Determination 2017/045

Regarding compliance of a barrier to a swimming pool at 5 Hillary Street, Chedworth, Hamilton

This determination considers the compliance of a number of features in a barrier to a swimming pool, including a bifold window that was installed as part of an alteration for which a code compliance certificate has been issued.

Figure 1: Kitchen plan (not to scale)

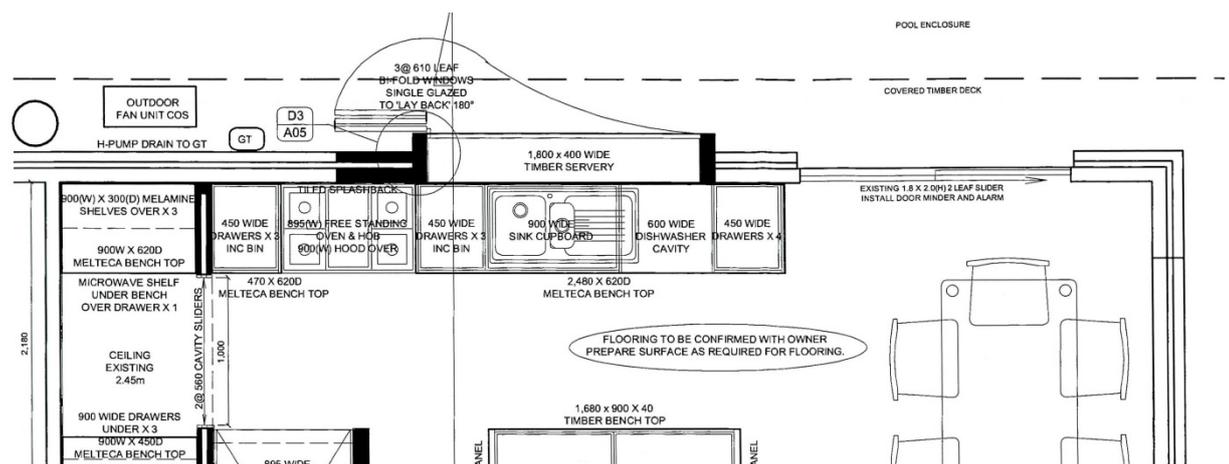
- 4.2.12 It is apparent on reviewing the drawings provided for the building consent application that there is conflict between the drawing itself, which shows the bifold window in a fully open position, and the notes alongside the drawing which state the window must have self-closing latches and restrictors fitted (refer paragraphs 2.4.2 and 2.4.3). This issue of conflicting information should have been addressed in the design stage before the building consent was issued. I have seen no correspondence or other information relating to the processing of that building consent that would indicate the conflicting information was identified by the authority and resolved with the designer or the applicant before the building consent was granted.

- 4.2.13 The authority is now of the view that the bifold window does not comply with the Building Code that was in force at the time the building consent and code compliance certificate was issued; preferring the requirement set out in the notes over the drawing itself. This implies that the authority now considers it issued the code compliance certificate in error⁵.

- 4.2.14 I have received no information that would indicate the bifold window had a self-closing mechanism or restrictors at the time of construction. The notes requiring restrictors to limit the opening of the bifold window to 100mm clearly conflicts with the function of the bifold window as a means of providing access between the kitchen and the servery in the immediate pool area; which indicates that the restrictors may never have been installed. That the authority inspected and approved the building work indicates the authority had formed a view at the time that the bifold window, capable of being fully opened to provide access to the servery, complied with the Building Code.

- 4.2.17 The design of the kitchen bench includes a set of drawers at one end, which makes it easier for young children to climb up onto the bench and access the window. In addition, as the window has been installed adjacent to the bench and not on the other side of the servery as shown in the plans, the open window is more likely to be visible to a child in the kitchen area.

- 4.2.18 Given the location of the bifold window and features of the adjacent kitchen bench, I am of the view that the bifold window without self-closers and without restrictors does not comply with the requirements of Clause F4.3.4(f) of the Building Code that was in force when the building work was consented.
